FIELD INSPECTION

Project Name:	Mountain Valley Pipeline	Inspector:	Matthew Grant
Inspection Date:	Thursday, December 12, 2019	Project Contact:	Brian Clauto
Spread: Franklin Co. MP 253.9- 254.1 ATWS 1351 MP258- 258.8 MP 256.1	Spread I	Weather (Wet/Dry/Rain):	Dry

FIELD INSPECTION PHOTO LOG

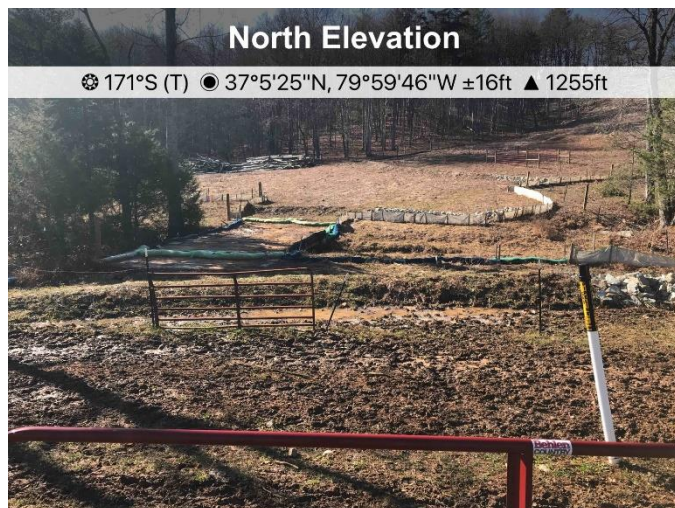
- Fig. 1. Designated stream crossing S-IJ4, slope requires additional stabilization.

- Fig. 2. Designated stream crossing S-IJ4, slope requires additional stabilization.

- Fig. 3. Designated stream crossing S-KL32, ECD's in place and functioning. Farming activities are ongoing in this area.

- Fig. 4. Designated stream crossing S-IJ 10, ECD's in place and functioning. Farming activities are ongoing in this area.
